**SPRINT SPECTRUM REALTY COMPANY, LLC**  
PETITION FOR A DECLARATORY RULING, FOR THE  
PROPOSED INSTALLATION OF A TEMPORARY  
ROOFTOP TOWER FACILITY AND ASSOCIATED  
EQUIPMENT TO BE LOCATED AT 201 HIGH RIDGE  
ROAD, STAMFORD, CONNECTICUT

PETITION NO. 1360

**PETITIONER'S RESPONSES TO  
SITING COUNCIL SET ONE INTERROGATORIES**

# Exhibit A

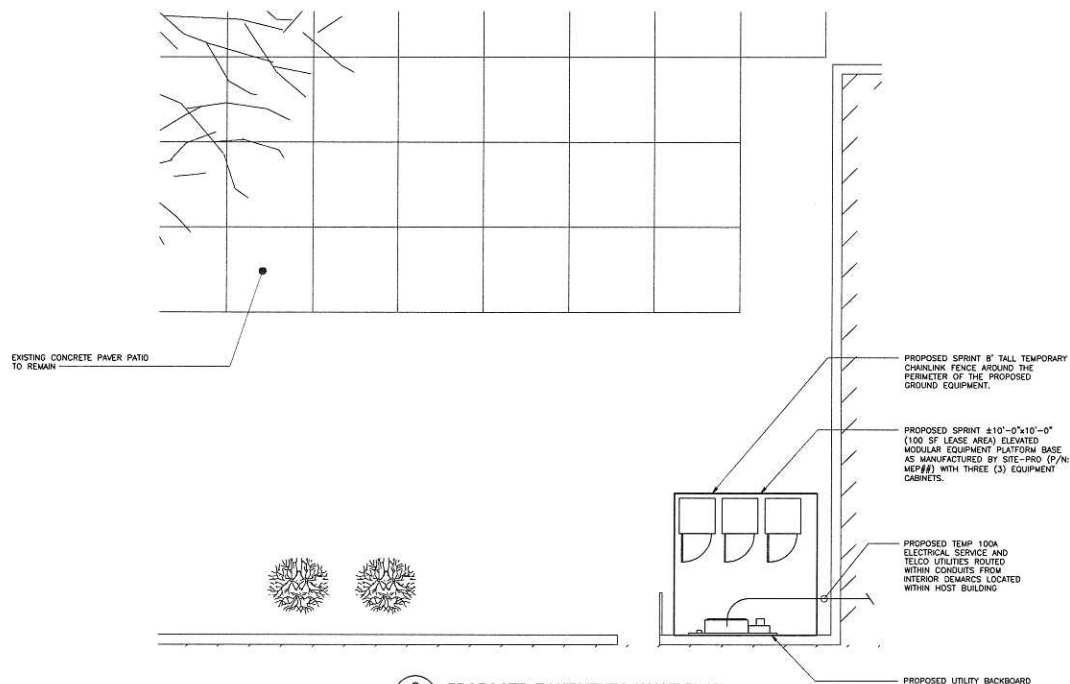
- Q2. Sheet C-4.0- South Tower Elevation indicates that the proposed antennas would have a centerline at the top of the tower. However, the drawing in the structural analysis shows the tops of the proposed antennas at the same height as the top of the tower. Explain. Also, would there be any conflicts between the proposed antenna attachment and the top set of guy wires?

- A2. *Please see revised sheet C-4.0 included as Exhibit A which shows the antenna installation matching the structural analysis report. The antennas will be face mounted to the temporary tower which eliminates any obstruction that might be caused by guy wires attached at the corners of the tower.*
